Memorandum

To: LPS School Community Project Number: 23090

Project Name: Lexington High School

RE: Community Provided Design Options
Distribution: Dore & Whittier, Town of Lexington

Option B4

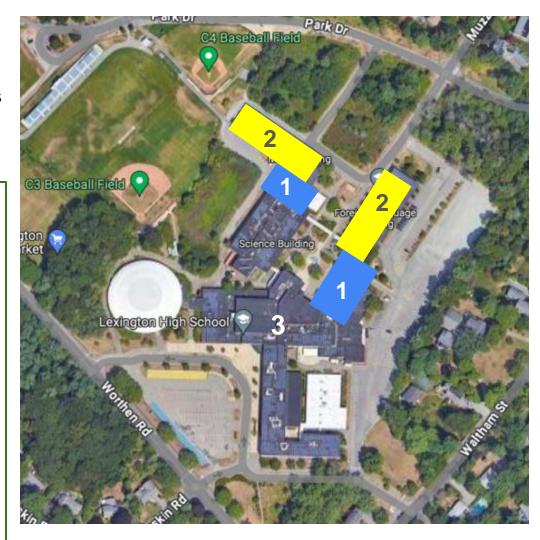
- The renovation of & addition of two stories above the 1960's vintage J & H buildings (Math & World Language) would prove to be challenging for the following reasons:

- The existing J & H buildings have a 10'-4" floor to floor height, which is much less than the preferred modern floor to floor height that is closer to 16'-0" which is needed for modern ventilation systems and desired air change rates. This could result in low ceiling heights or even the need to omit acoustic ceilings entirely and consequently create oppressive feeling interior environments with compromised acoustics, as is found currently in those existing buildings.

- o The column grid spacing of the existing J & H buildings is too dense to efficiently provide classroom sizes that meet the educational program (and MSBA) requirements. Existing rooms would need to be increased in size which would present the potential of freestanding columns being located in the midst of classroom spaces. Additionally, because the existing classroom sizes are insufficient, the classroom count capacity of these existing buildings would be reduced driving up the size of the new construction additions to accommodate the balance of necessary classroom spaces.

- o The structural logistics of adding two floors above the existing structure is enormously complicated by the geo-technical qualities of the surrounding soil which has a high organic content and is consequently considered "soft". The existing structure is not sufficient to support either the vertical gravity loads or lateral loads of floors being added above. Any new structure for floors being added above would need to be located around the perimeter of the existing structure and laced through the center of it, which would erode much of the historic character/value of these buildings. This would also

involve an extreme cost premium and schedule impact due to deep foundation work and shoring of the existing structure during construction.

- The construction of new and/or addition/renovation four story structures on the northern edge of the site while renovating the two story 1950's vintage structures on the southern side of the site will create vertical discontinuity of the educational environment. The upper floors to the north will feel disconnected from the remainder of the school, and will create circulation bottlenecks as students need to move up into and down from the higher stories.

- The same challenges noted above for the prior community scheme regarding the renovation of the 1950's A & B wings would exist with this option.
- As an addition-renovation option that looks to re-use the majority of the
 existing structures, construction would be both highly disruptive to existing
 portions of the building which remain in operation, and would require the use
 of costly and non-MSBA reimbursable temporary modular classroom
 buildings. Similar to the comments provided for the prior community scheme,
 the presence of temporary modular classroom facilities and/or the other
 construction related activities on the site will impact the existing fields and
 parking lots, so these could not remain unaffected.
